COMMITTEE Enterprise Planning and Infrastructure

TITLE OF REPORT Request for a 30mph speed limit, section of old Lang Stracht

REPORT NUMBER: EPI/10/063

Appendix 1

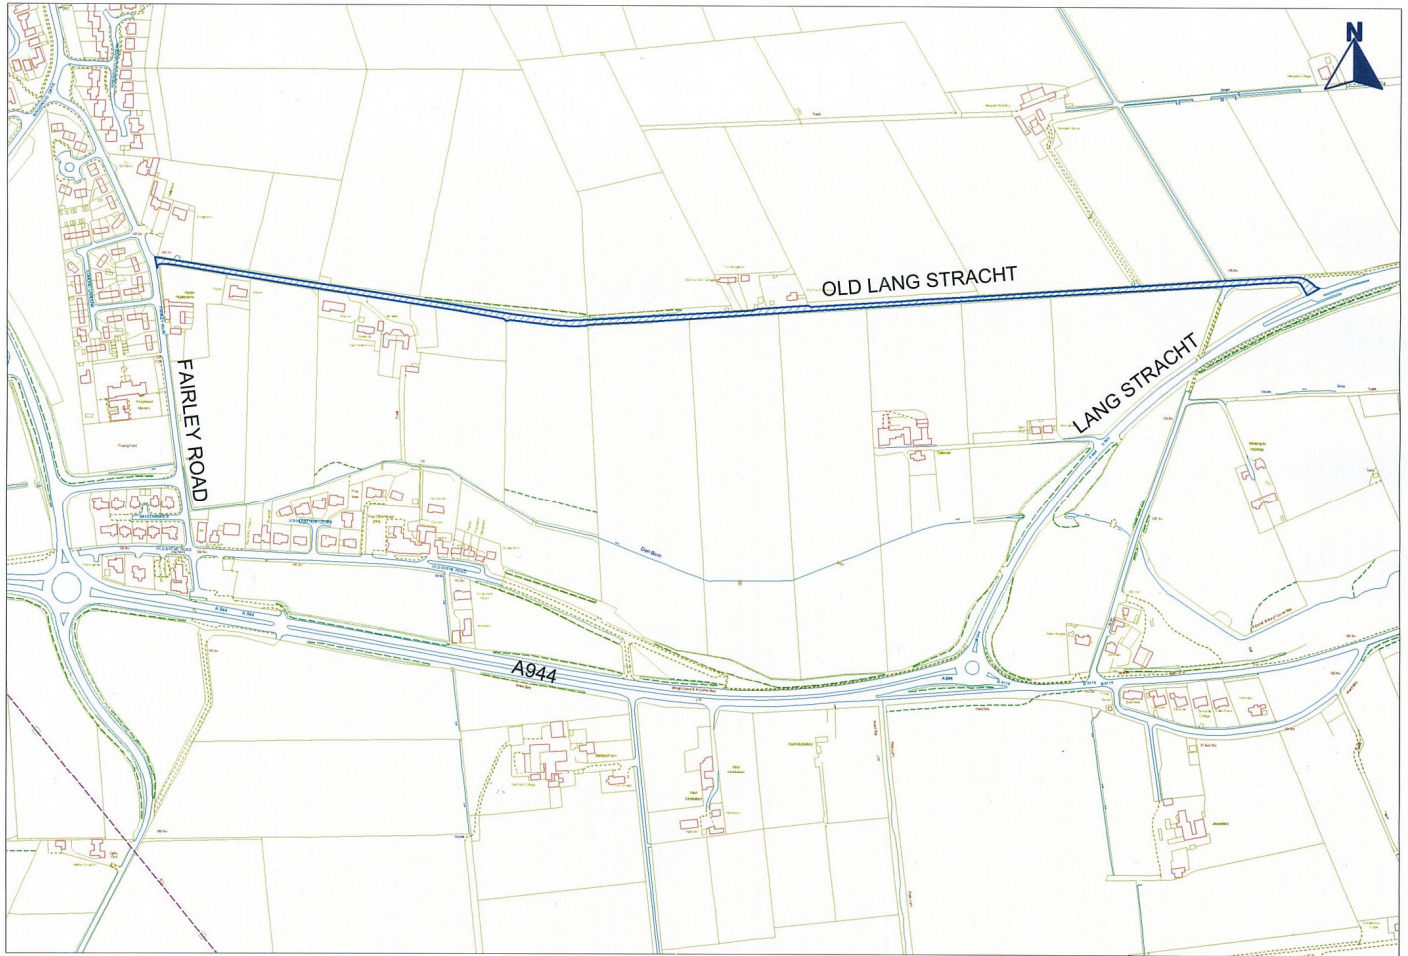
6.1 Over a number of years Aberdeen City Council has received various complaints from residents of the Lang Stracht who have raised concerns over the inappropriate use of the old section of the Lang Stracht (see appendix 1). The concerns relate to vehicles disobeying the “prohibition of driving” restriction (except for access and buses), vehicles driving at excessive speeds, the obstruction of free flowing two-way traffic resulting in erosion of verges, potential problems for residents exiting from their properties and the subsequent vulnerability of pedestrians and cyclists on this route.
